RFI 142

Project: COOLEY LABORATORY RENOVATION
Job: 3146 COOLEY LAB, PPA# 10-0023
Customer: STOFMT MSU BOZEMAN
Issued To: CONSTRUCTION MANAGEMENT SERV.
P.O. BOX 7274
BOZEMAN, MT 59715

Item: FIRE ALARM ARC/LEWIS/COOLEY VESTIBULE Type: FIRE ALARM
Reference: E2.1 Spec. Section:
Attachments:

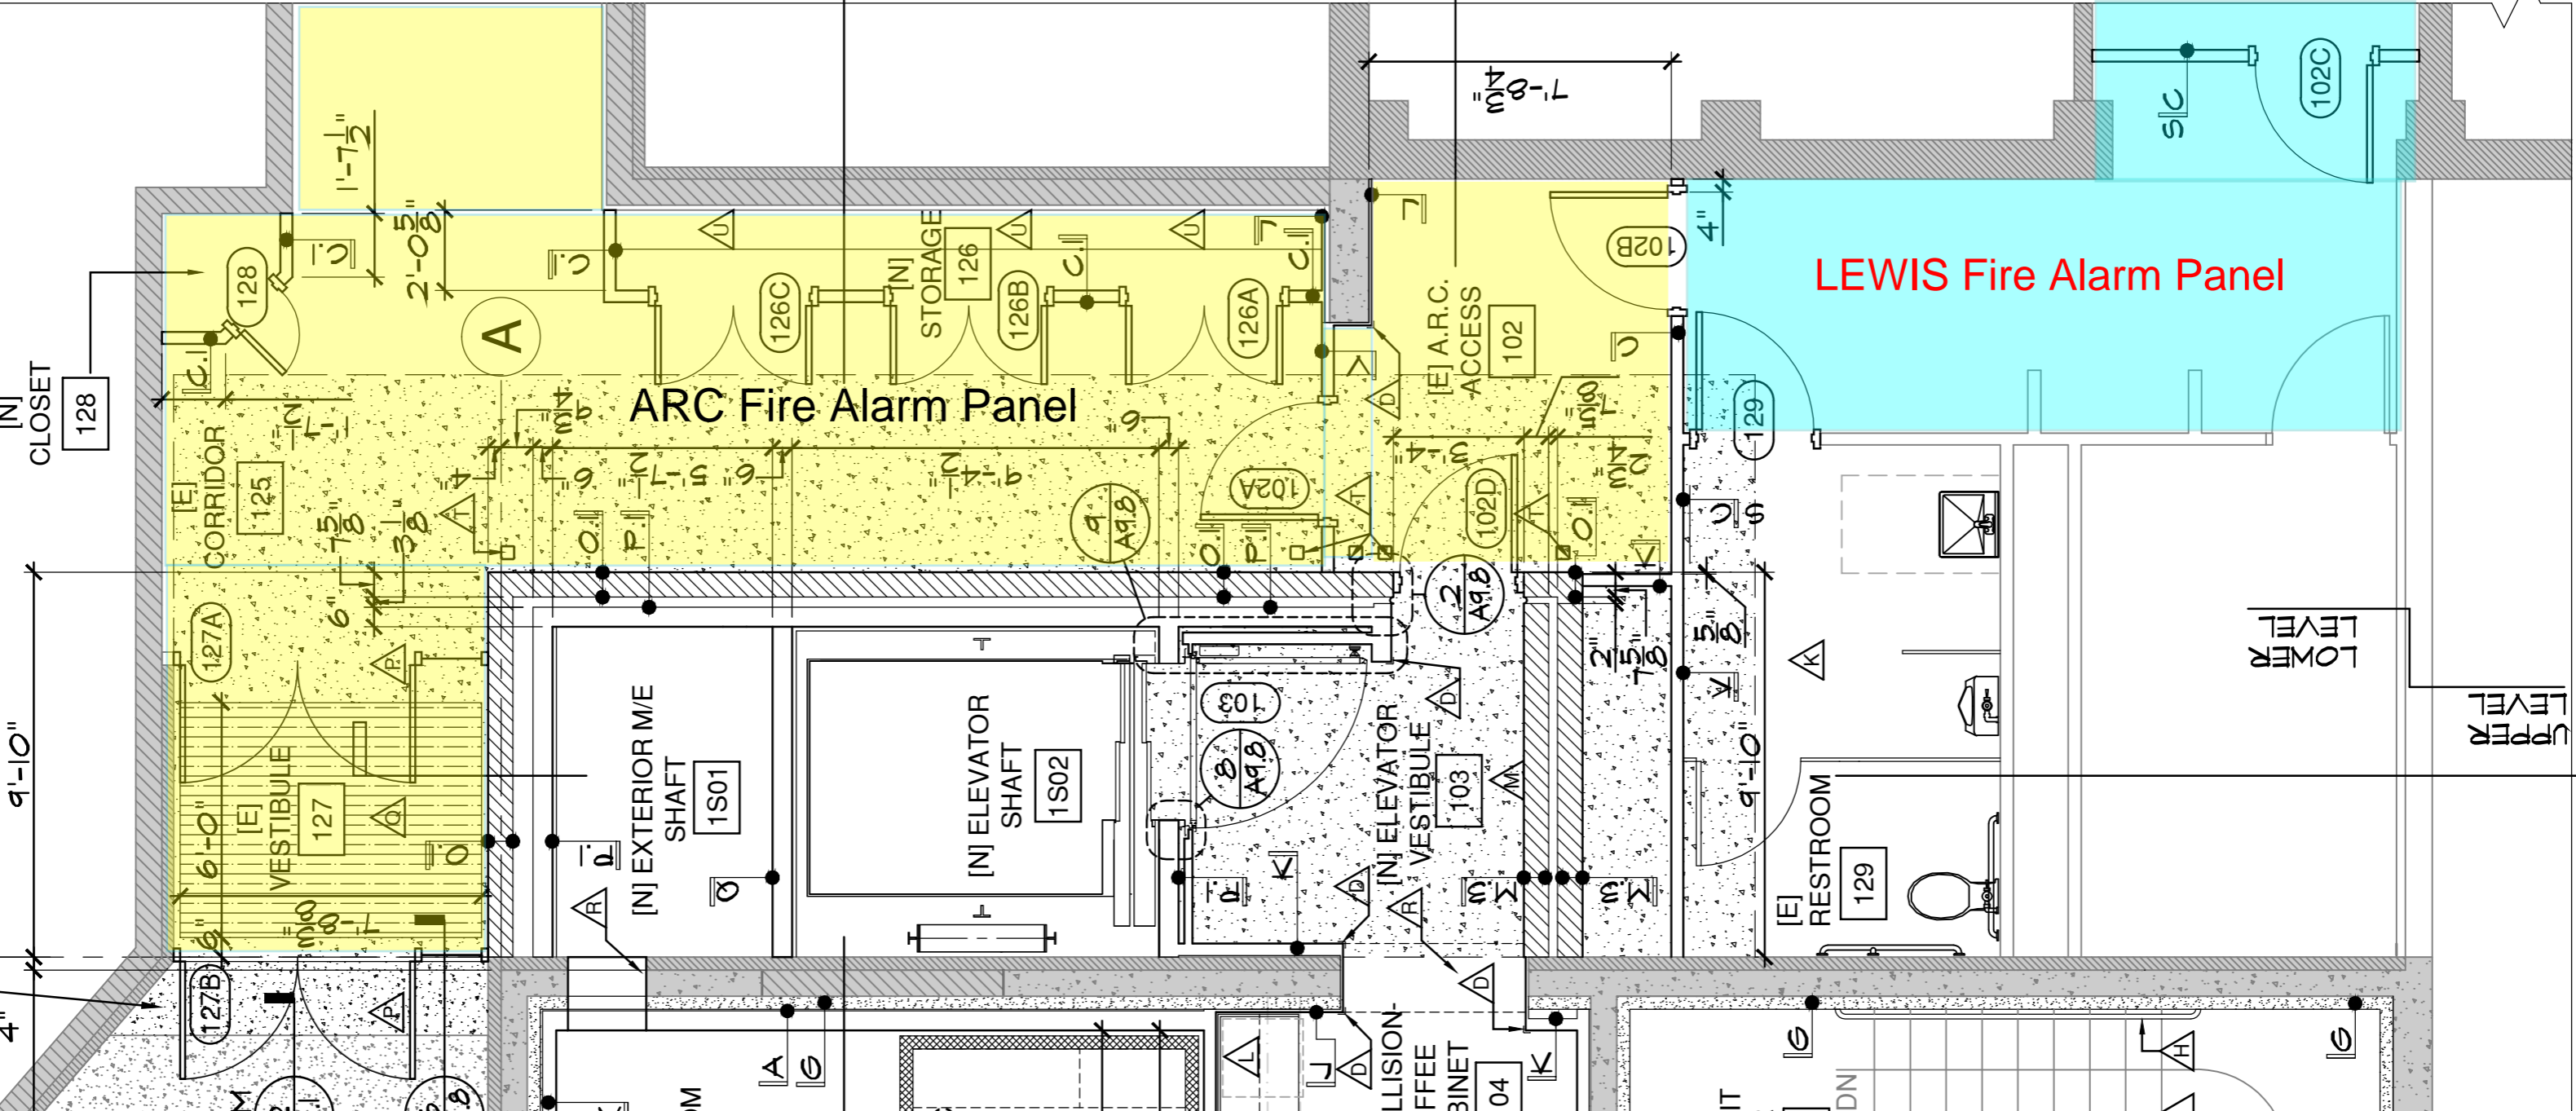
In the ARC/Cooley/Lewis walkway/intersection which building does the the fire alarm pulls and horns and strobes integrate with? If an event happens in this intersecting space which buildings should be alarmed?

To remain as they were pre-construction;

All devices located within the corridor North of door 102B should integrate with ARC Fire alarm Panel
All devices located within of the corridor South of door 102B should integrate with the Lewis Fire Alarm Panel.

I met with Skip Hougland about the alarm in the connecting corridor between Cooley, Lewis and the ARC. He wants that alarm only to tie into one panel, and feels that should be for the ARC. This is where it was originally connected.
